AS-BUILT			
	Sign	Name	Date
Originator			16.03.2016
Site Approval:			16.03.2016
Office Approval:			16.03.2014
WEL Controlled #	M5000P544.03	Rev	7A
Project Number:	N/A	Job No.	N/A

The KVAERNER-SBM Consortium Kvaerner Engineering a.s. / Single Buoy Moorings Inc.	
Drawing Title	UTILITY P&ID DIAGRAM PRODUCED WATER DEGASSING DRUM
Drawing No.	M5000- DP-544.03
Proj. Code	P4303
Discipline	Process
Seq. No.	7
Sheet No.	7A

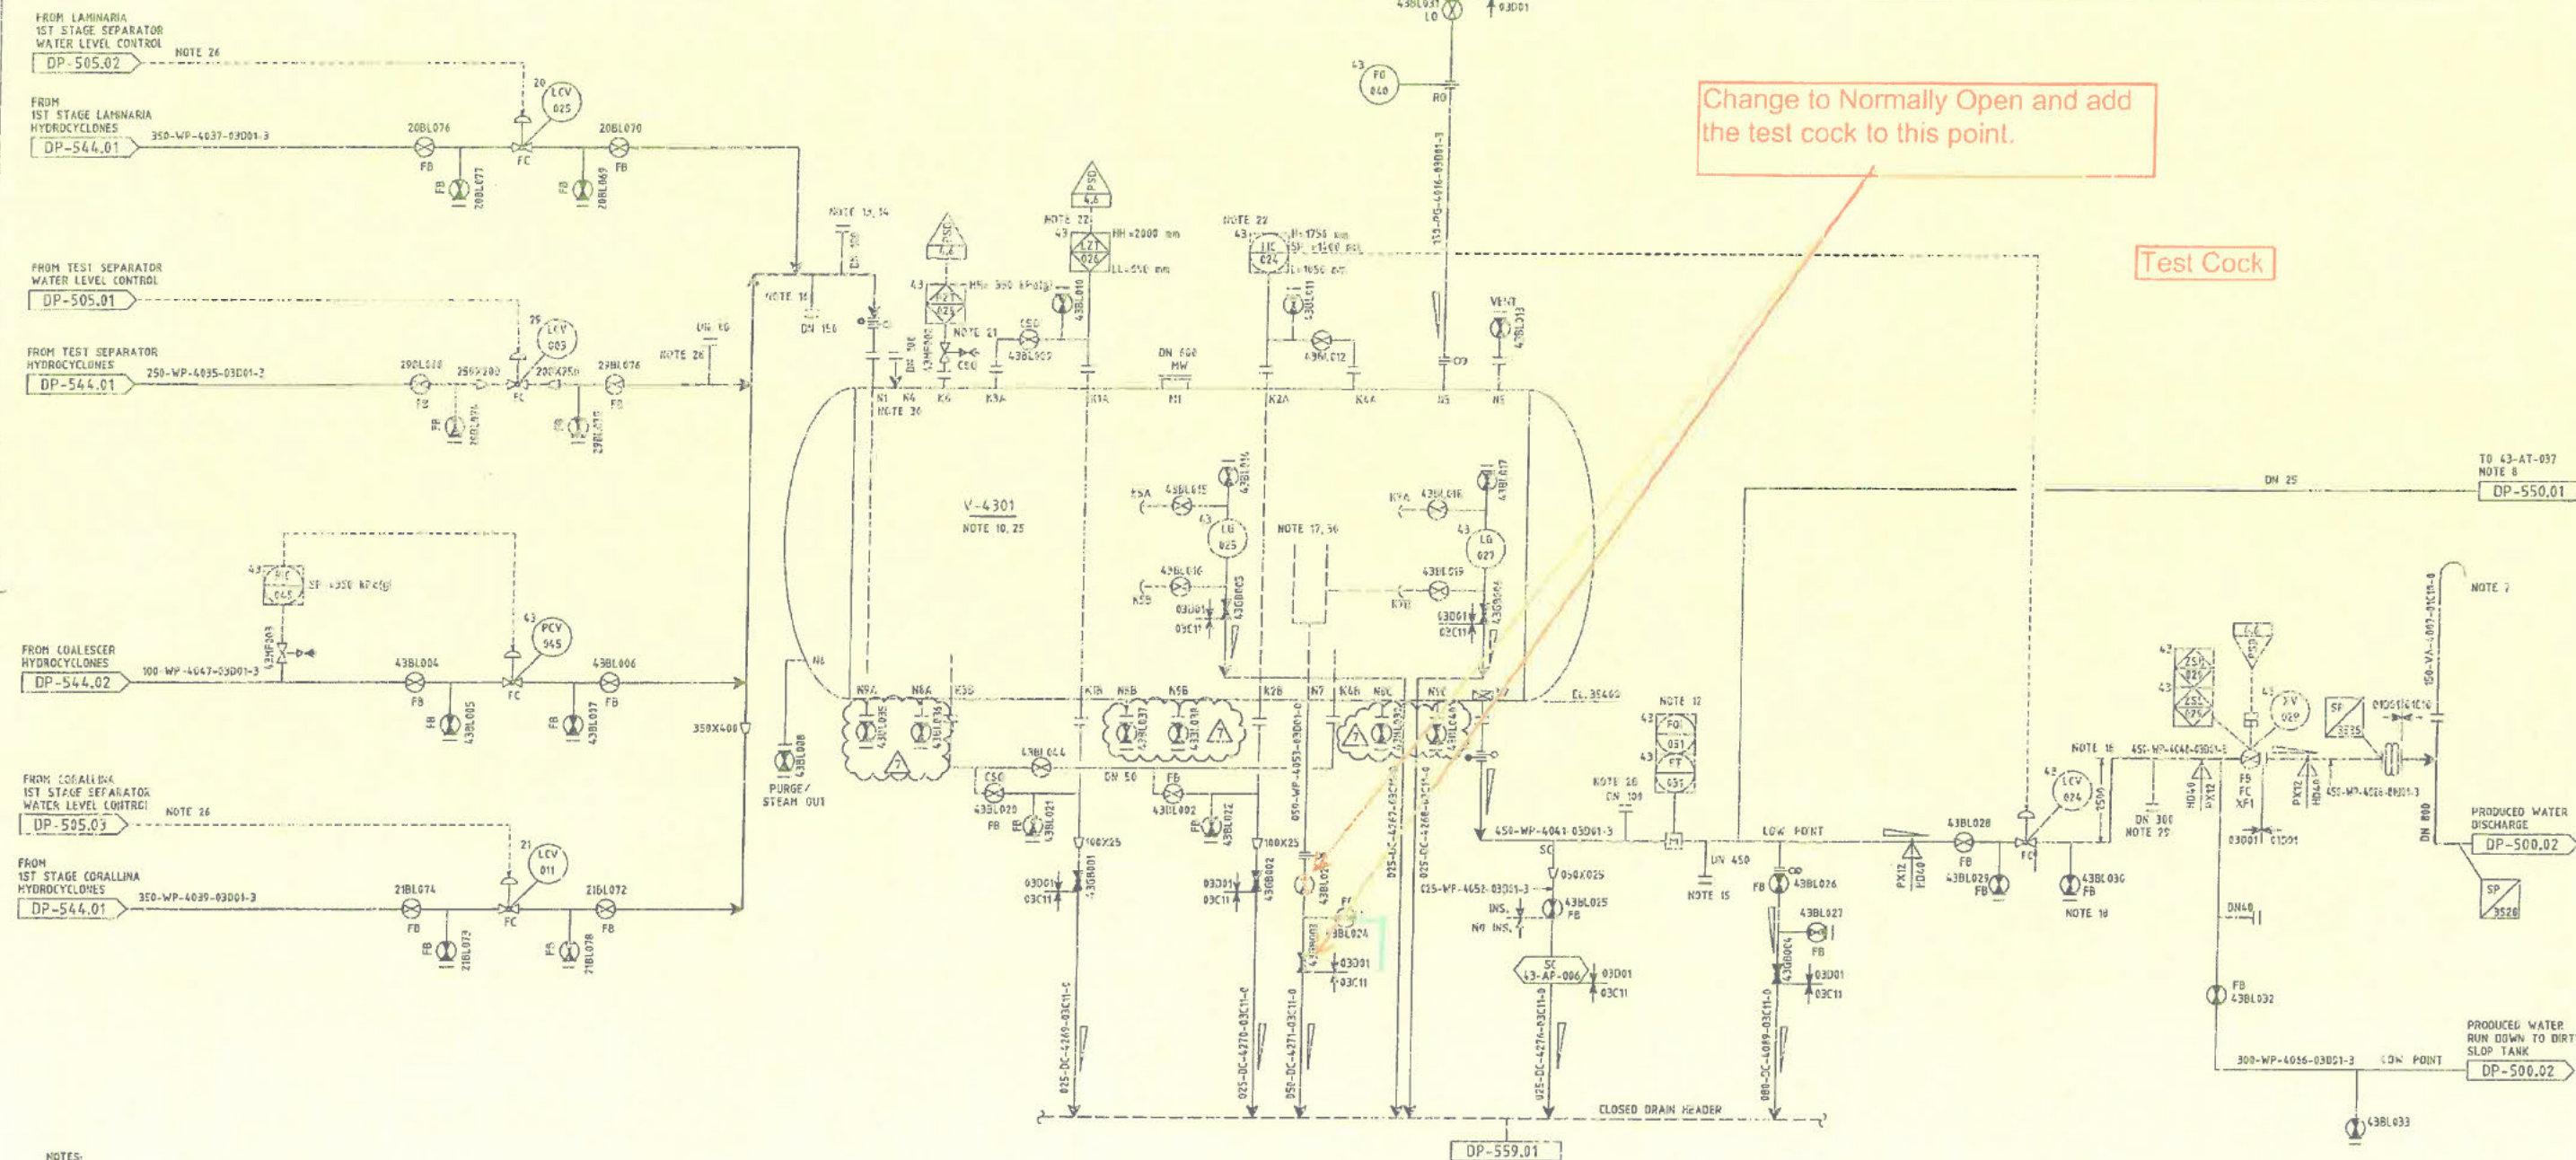
Change to Normally Open and add the test cock to this point.

Test Cock
